**CITY OF PORTLAND, MAINE
DEVELOPMENT REVIEW APPLICATION
PLANNING DEPARTMENT PROCESSING FORM
Planning Copy**

2002-0234
Application I. D. Number
10/29/2002
Application Date
1 2-story 4-unit building (lot 2)
Project Name/Description

Gorrill-Palmer Consulting Engineers, Inc. is pleased to respond to the review comments we received in an e-mail from Jim Seymour at Sebago Technics, regarding the above referenced project. For ease of review, each of the comments are repeated below followed by our response.

Drawing Name:	Site Layout & Utility Plan, Lots 1 & 2
Project:	MAGGIE LANE, PORTLAND

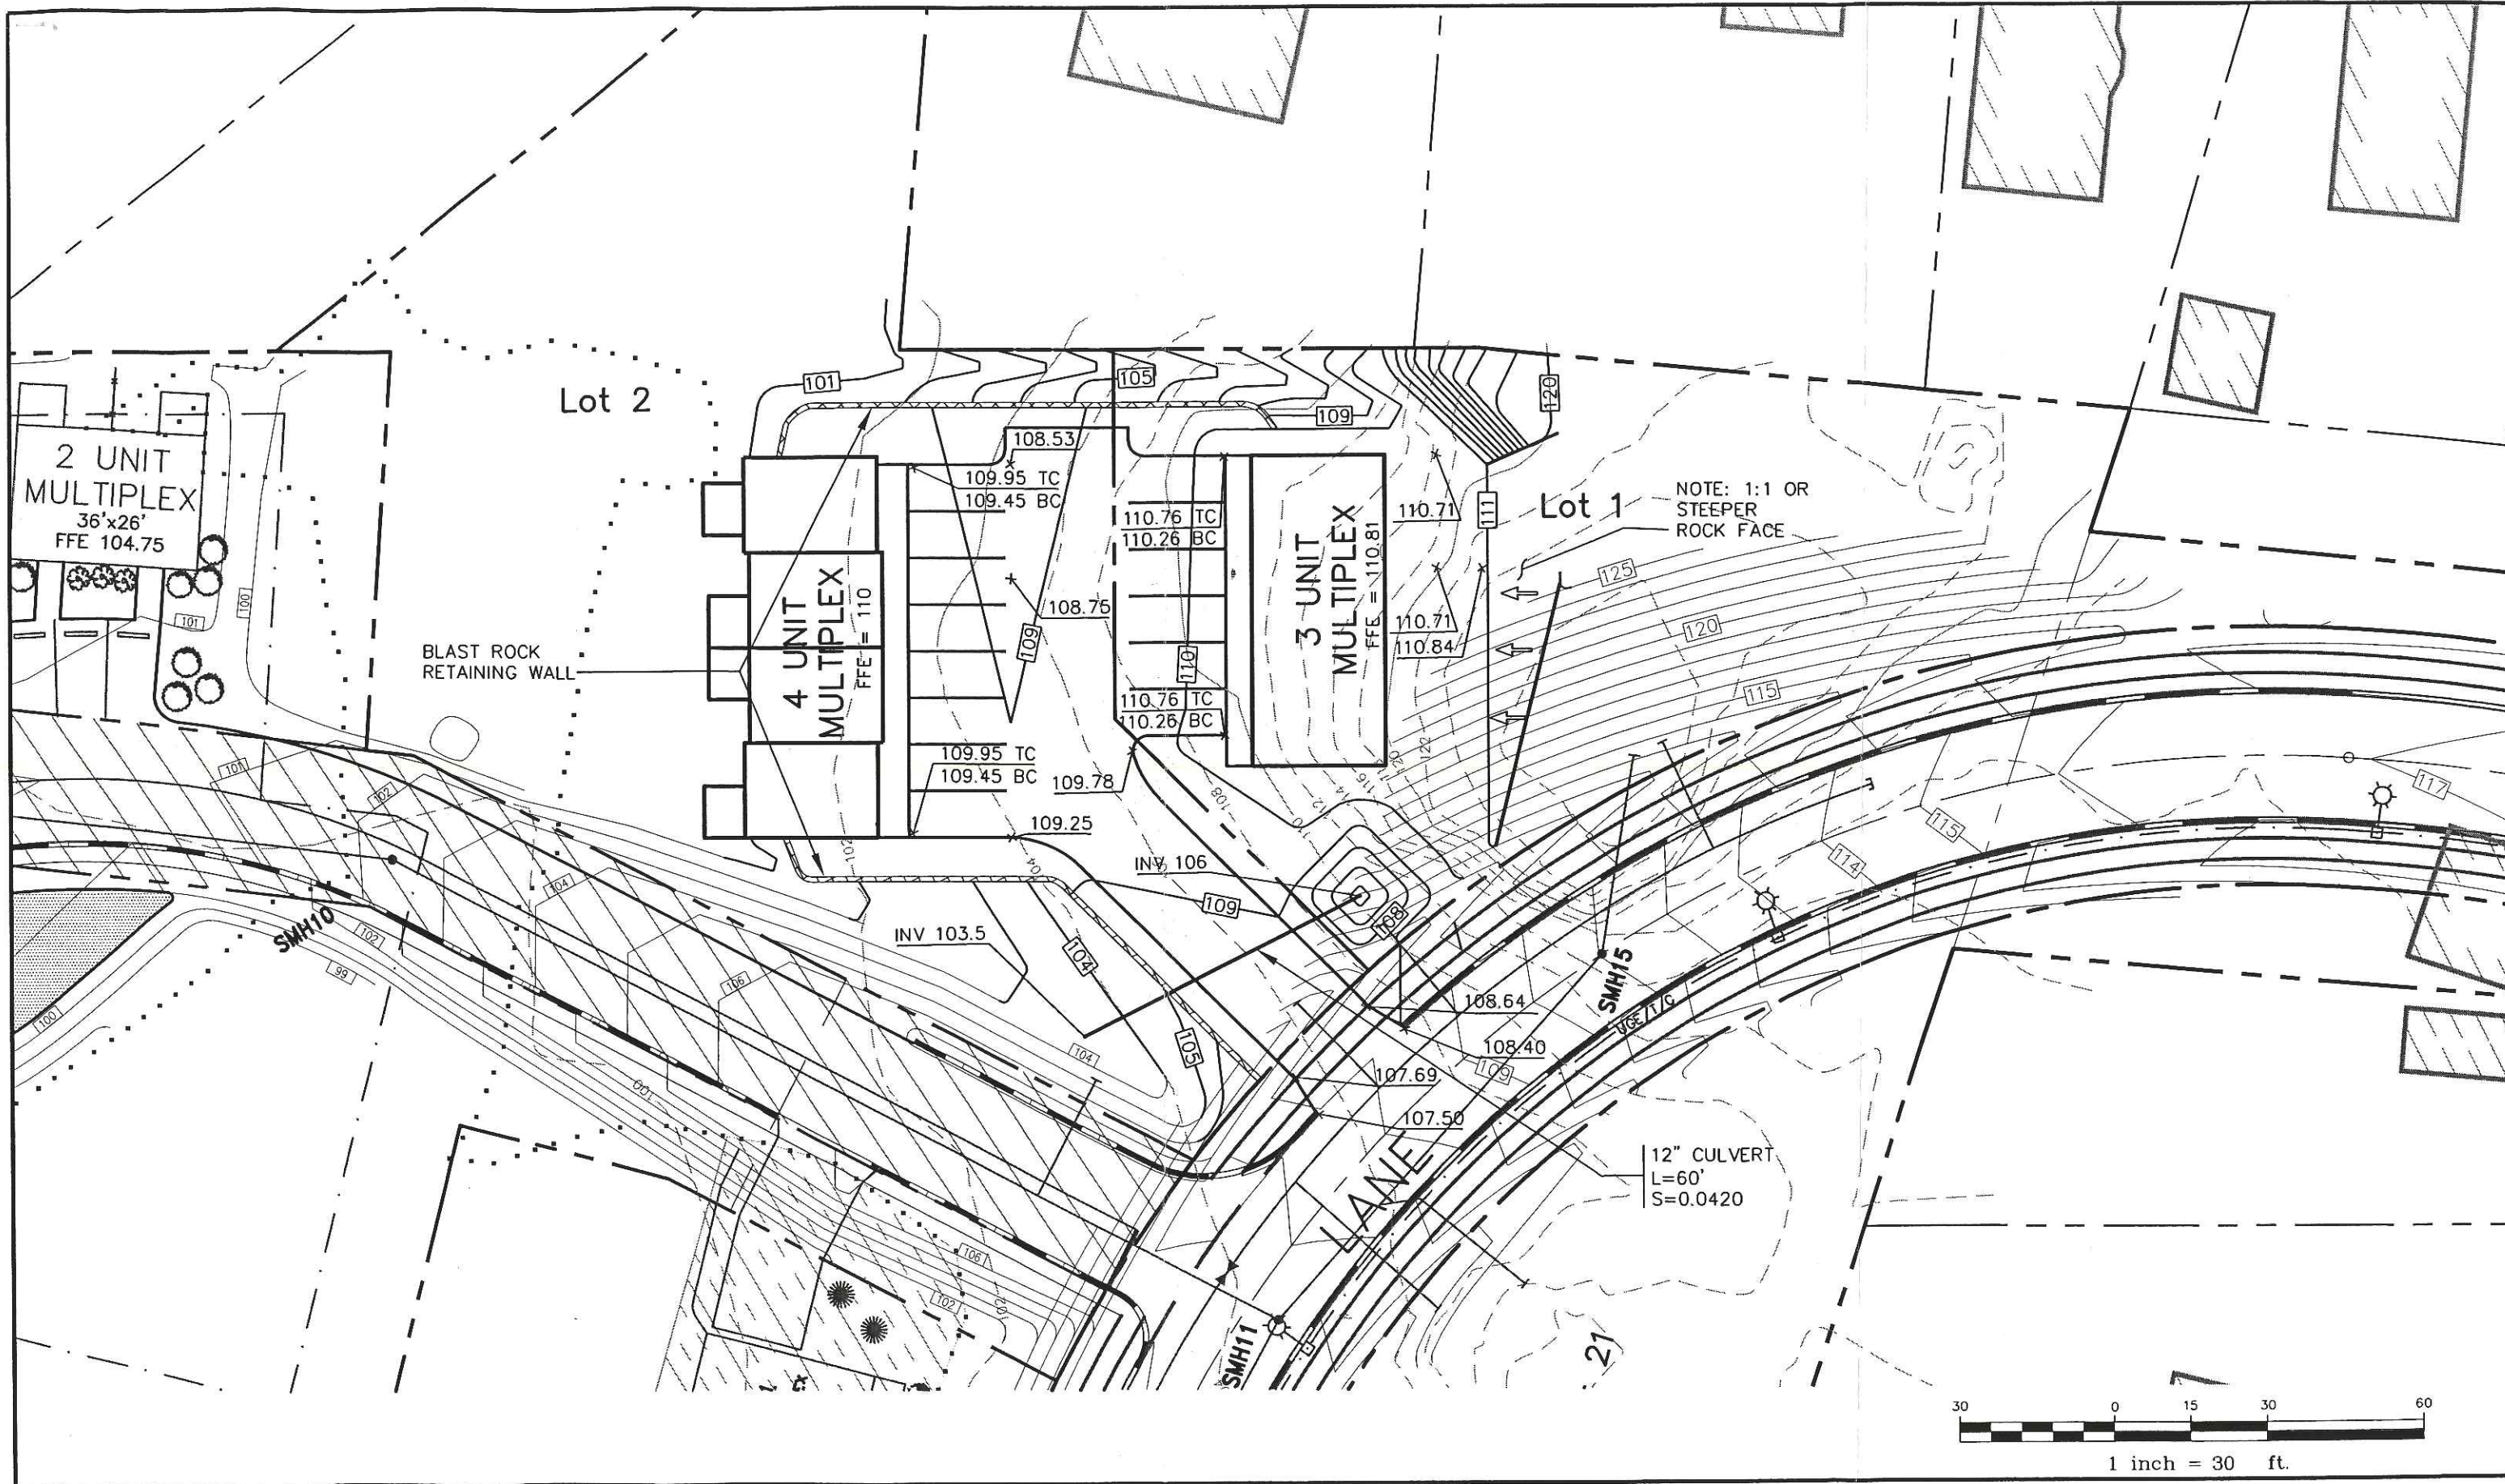
Comment 4A - The existing catch basin and stormdrain infrastructure located up gradient of the driveway curb cut on Maggie Lane should be shown on the appropriate plans.

Comment 4F - Show proposed electric services into site.

Response – The appropriated structures have been added to the plan.

Response – The approximate location of the existing transformer and potential electric services have been added to the plan.

Drawing Name:	Grading & Drainage Plan, Lots 1 & 2
Project:	MAGGIE LANE, PORTLAND

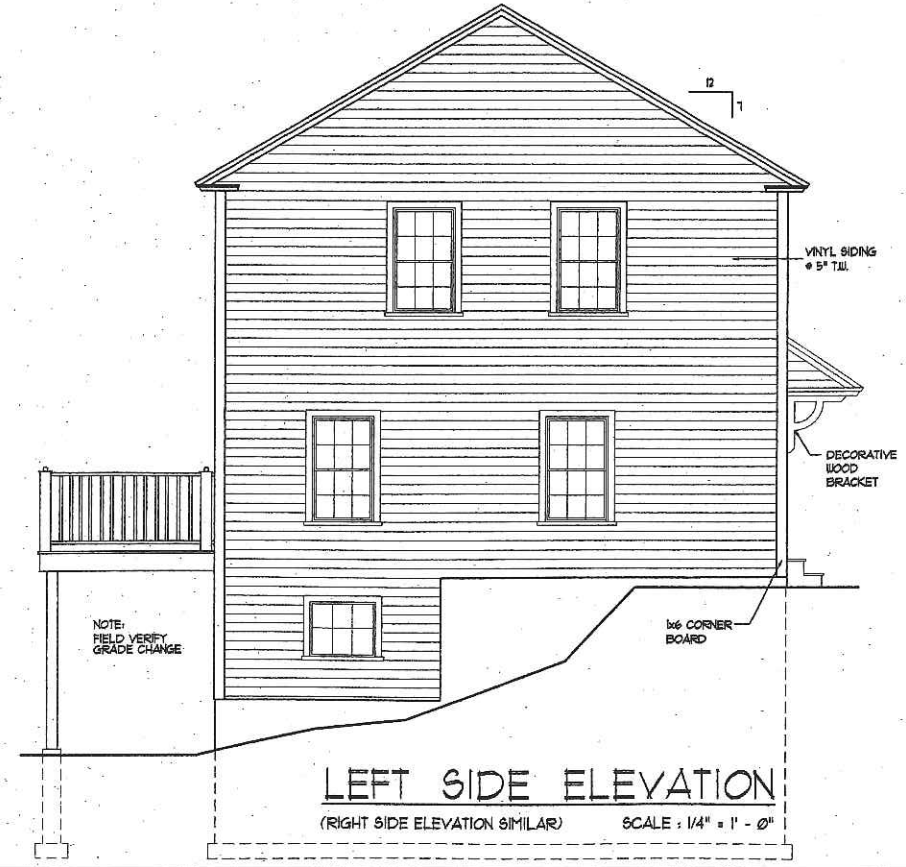
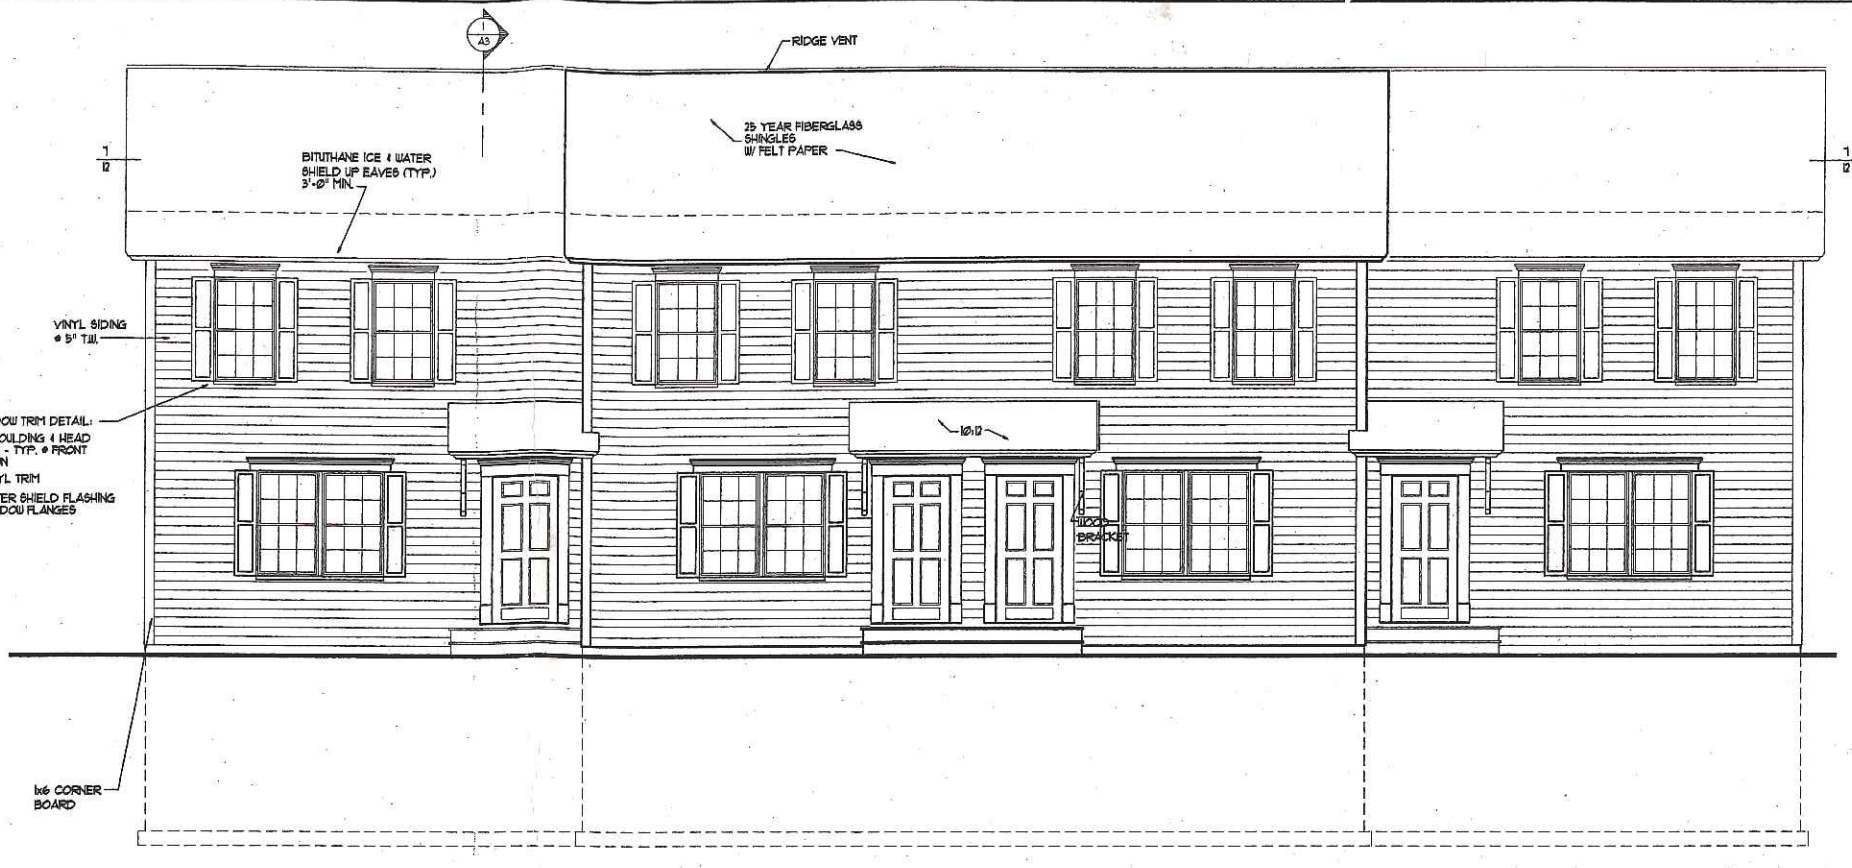
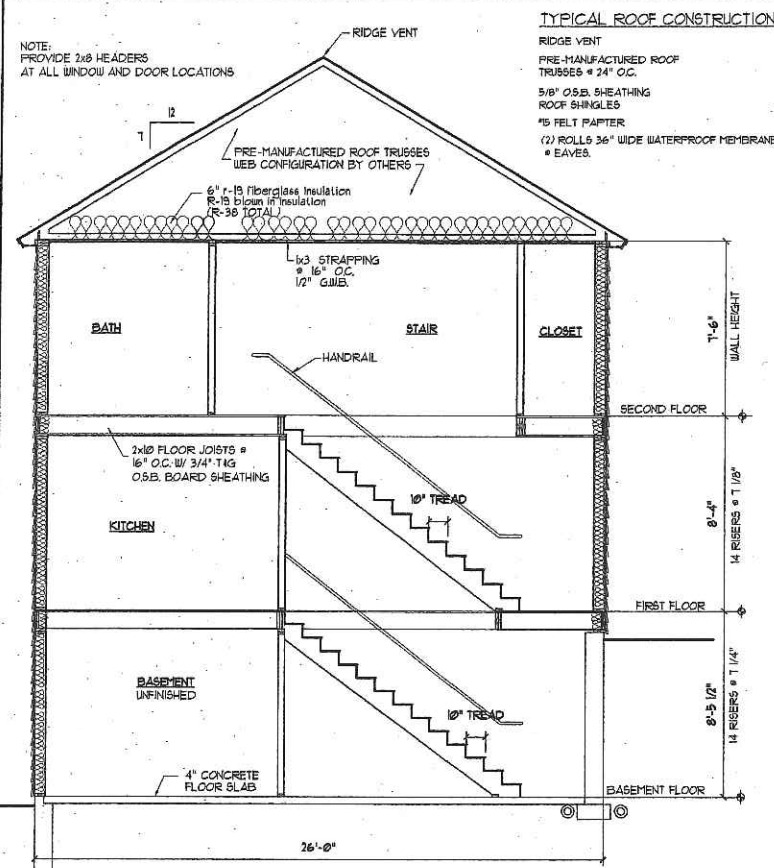
Comment 3C - Is any filling of wetlands proposed at the rear of the 4-unit multiplex? Both existing and proposed grades should be provided on the plans. What are the proposed grades at the building (basement FFE) relative to existing/proposed yard elevations/grades.

Comment 3D - The driveway culvert should include riprap inlet/outlet aprons.

Comment 4D - We recommend that finished floor elevations be raised relative to sidewalk elevations. The Grading Plan indicates a 0.05' differential between the front edge of curb and F.F.E. Assuming the sidewalk will presumably have a cross slope of 1% to promote drainage, FFE will match the sidewalk grade. This is not an ideal situation.

Comment 4E - The area between the 3-unit multiplex and the proposed rock face should be ditched to promote better drainage.

Response – No additional wetland fills are required at the rear of the 4 unit building, whereas the portion of the building that is depicted adjacent to the wetlands is an elevated deck. Basement finished floor elevations have been added to the plan. The grades along the rear of the building have been spot graded as requested.

Response – Based upon conversation with City Staff, the roadside ditch, which is depicted on the grading plan does not exist in the field, therefore would not require a culvert under the proposed drive. The driveway culvert has been eliminated from the design.

Response – The finished floor elevations have been raised as requested to remedy the situation.

Response – Spot grades have been clarified to depict a swale to promote drainage behind the three unit building.
